MAGNACHECK INCORPORATED
2125 RIGGS
WARREN MI 48091 13AM

REQUEST INTERIM LICENSE BASED ON PREVIOUS LICENSE NO 21-19111-01 AND
ADMINISTRATIVE MANUAL/OPERATING AND EMERGENCY PROCEDURES WITH NO
CHANGES. LICENSE FEE TO FOLLOW.

Magna Check - Shielding

MAGNA CHEL, INC.
WARREN, MICHIGAN
DESCRIPTION OF RADIOGRAPHIC
EXPOSURE AREA

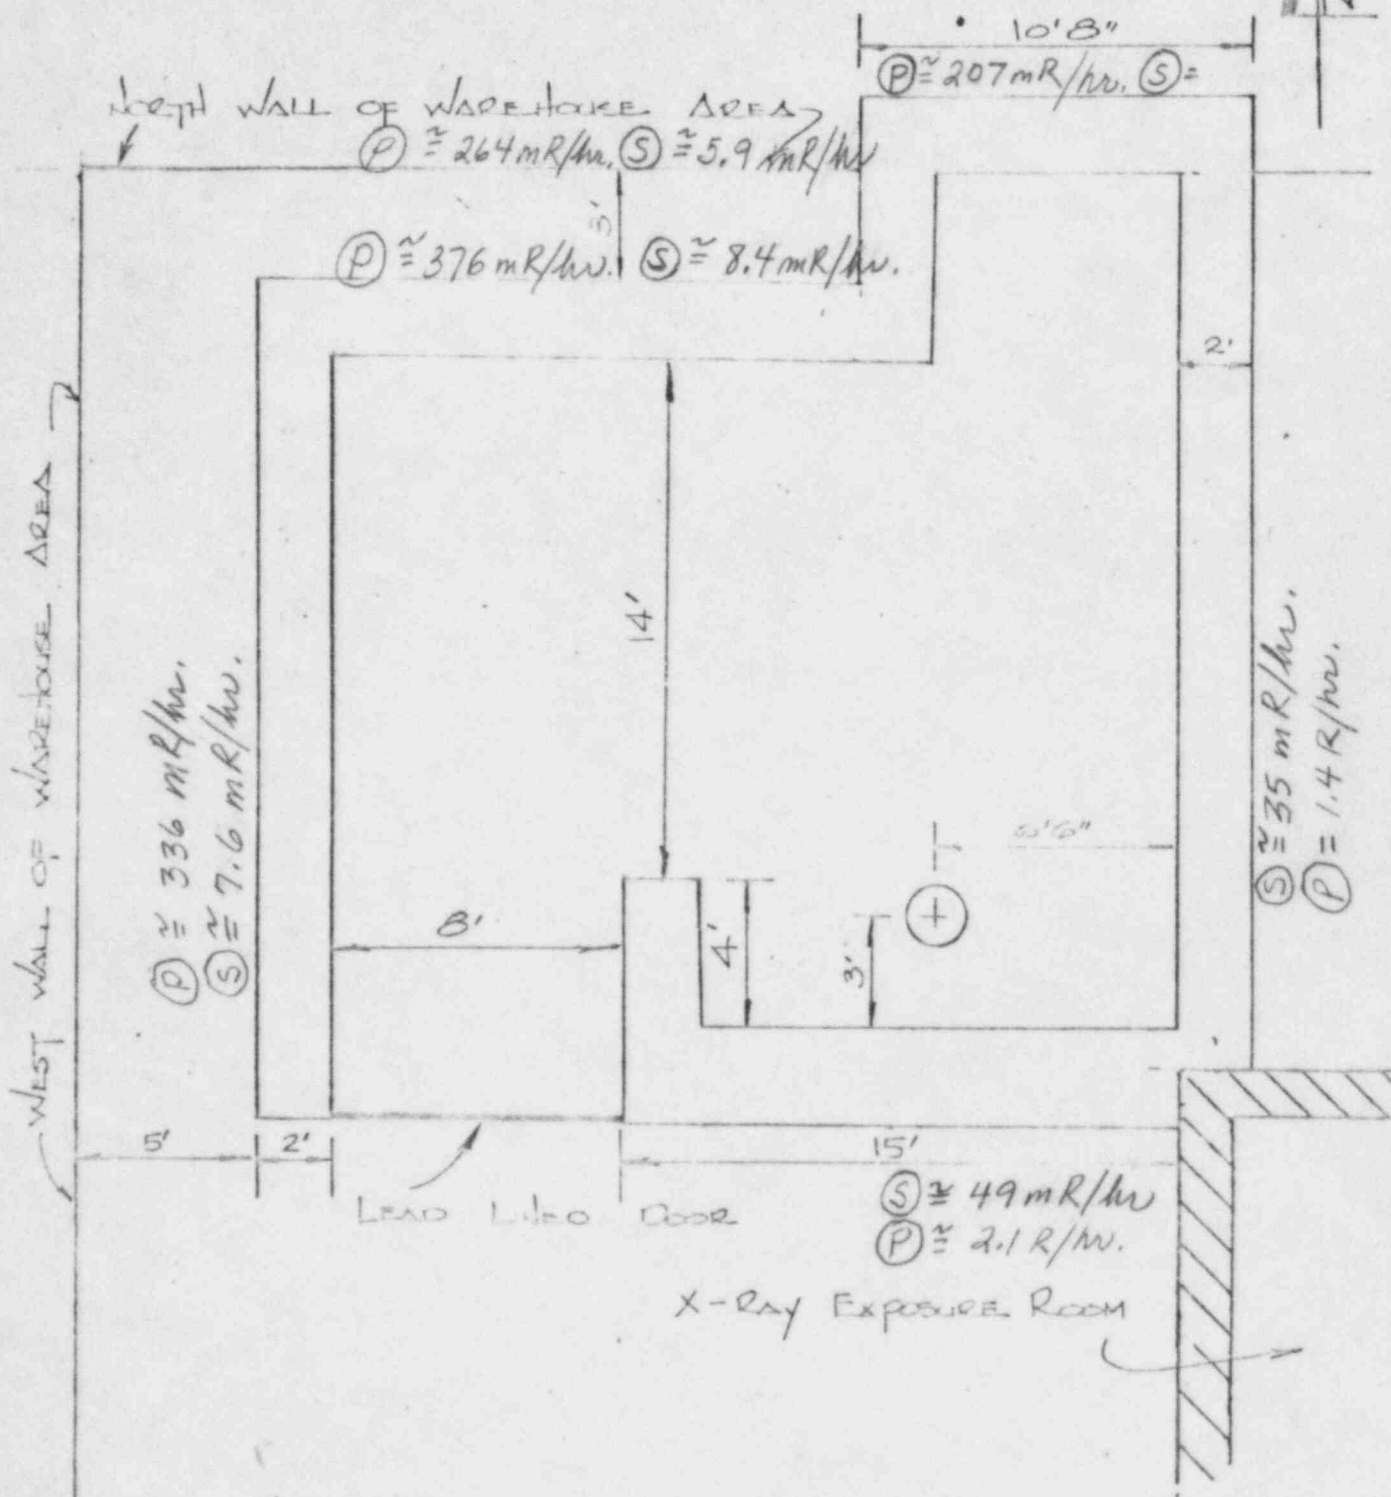
Deficiencies:

- (1) Need to submit survey report as required by 4/c. No. 16.
- (2) Prior to authorization for 1,000 Curies:
 - (a) Re-submit shielding evaluation.
 1. detailed calculations of max rad. levels in (restricted & unrestricted) each area adjacent to and above the radiography room. (see sample letter)
- (3) Rotation of Cyclops 0° (Strictly Vertical up & down)
(Confirm)
- (4) How high from floor (is Cyclops fixed at 40")
- (5) Calculate or give Field size at use distance.
